# SAFeway REDEVELOPMENT PROJECT BROADWAY AND PLEASANT VALLEY AVENUE

## FINAL ENVIRONMENTAL IMPACT REPORT

SCH# 2009062097

## NOTICE OF RELEASE AND AVAILABILITY OF FINAL ENVIRONMENTAL IMPACT REPORT AND NOTICE OF PUBLIC HEARING

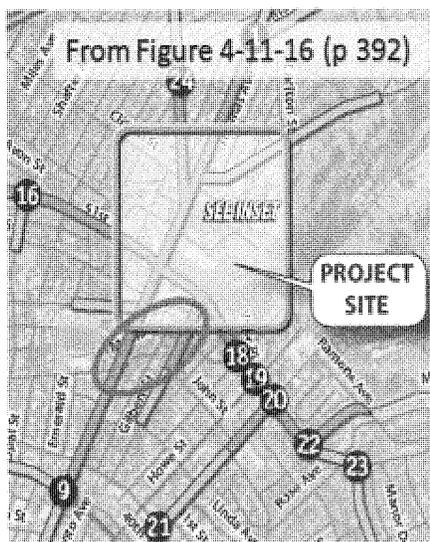
Traffic impacts of the proposed project are sure to land along the streets closest to it, especially Mather, Gilbert, Whitmore, Montgomery, Howe, Coranado and Desmond as illustrated below:

However, the parking and trip impact studies didn't even cover Mather. It's omission is visually striking in the following two illustrations pulled from the report.

As stated in the comment, the existing on-street parking occupancy shown on Figures 4.11-5 through 4.11-7 did not include Mather Street between Broadway and Gilbert Street. Since other residential streets closer to the Project site have low parking occupancies and more likely than Mather Street to be potentially used by Project employees and customers, it is unlikely that on-street parking on this segment of Mather Street would be used. However, based on data collected in May 2013, this segment of Mather Street has a supply of about 45 on-street parking spaces which have a typical occupancy of about 84 percent during the weekday and 58 percent during the Saturday peak periods. The parking occupancy on Mather Street does not change the Draft EIR conclusions regarding parking at the Project site.

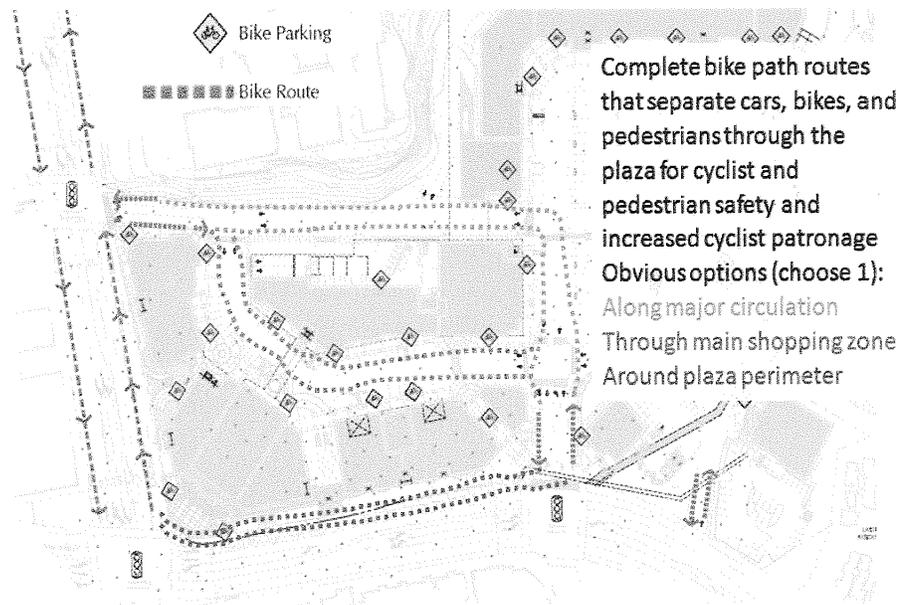
As the figure below illustrates, there are some bike paths into the plaza, but they are incomplete. The possible completed routes are rather obvious and I've colored them in.

From Figure 4-11-7 (p 356)

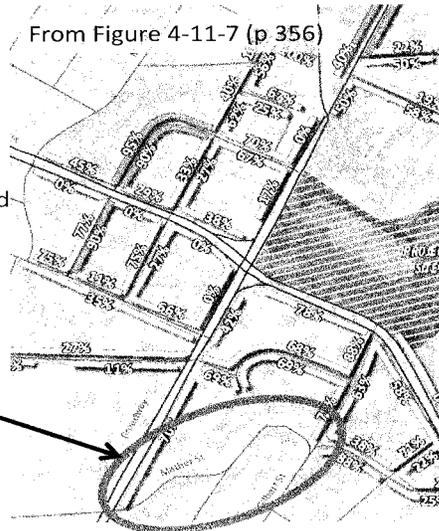
Mather excluded from parking impacts study. Surrounding Streets suggest high % occupancy

From Figure 4-11-16 (p 392)

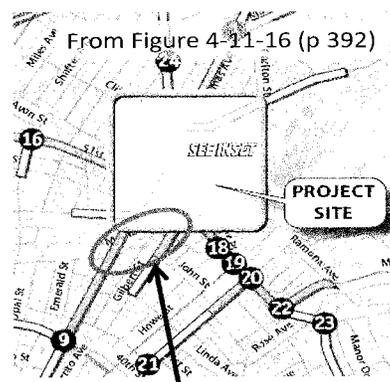
Mather excluded from trip impacts study. Surrounding streets And common sense suggest red = impact of greater than 30 cars/hr.

**Response 20-10:** The comment is consistent the Draft EIR which shows on Figure 4.11-15 that about seven percent of the Project generated traffic would use Gilbert Street to travel to and from the site.

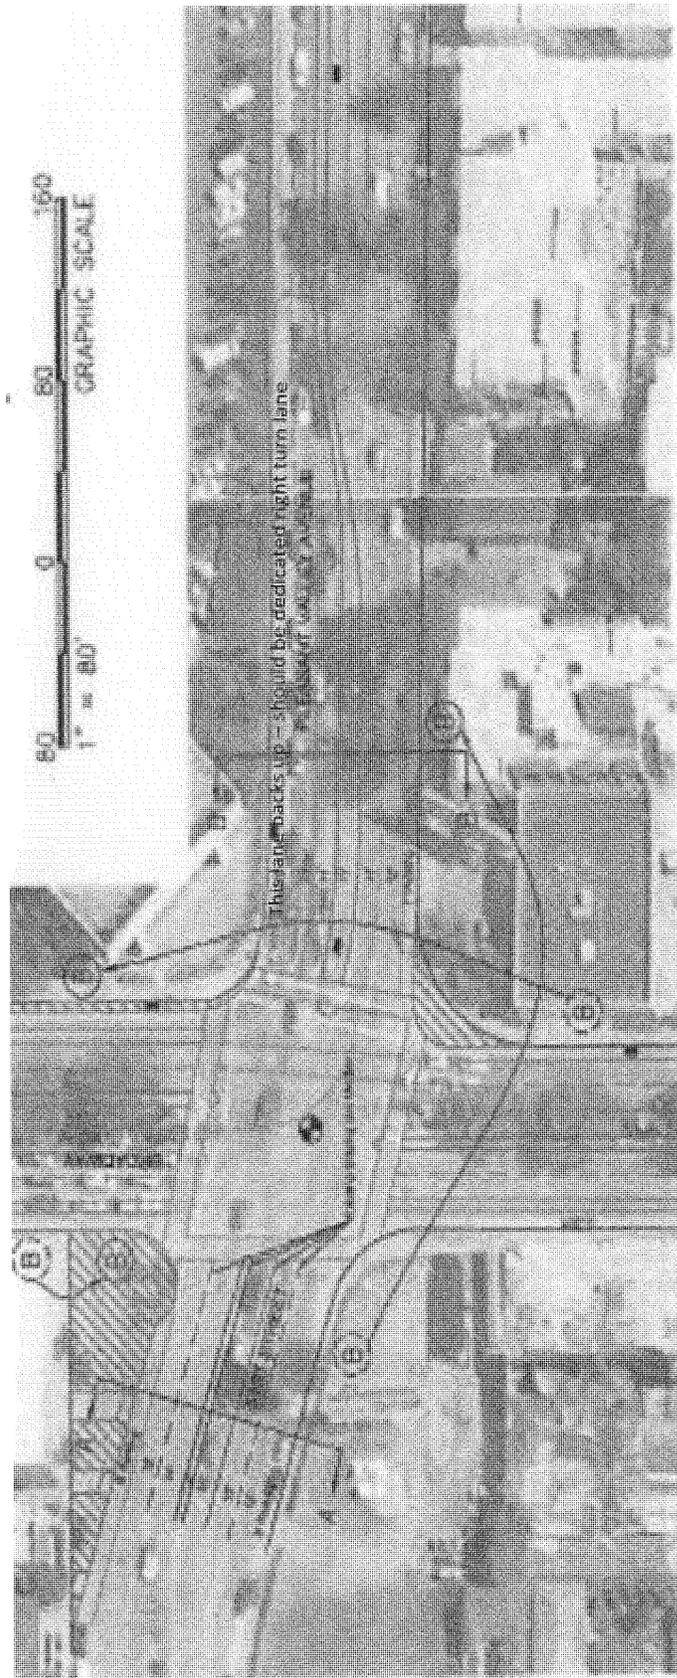
There are two dedicated left turn lanes from Broadway south to Pleasant Valley east, but in Safeway's plan, there are NO dedicated right turn lanes from Pleasant Valley west to Broadway north.

I recommend that the right-most lane on Pleasant Valley going west, approaching Broadway, should be converted to a dedicated right-turn-only lane. I am attaching a pdf of the recommended change in road markings.
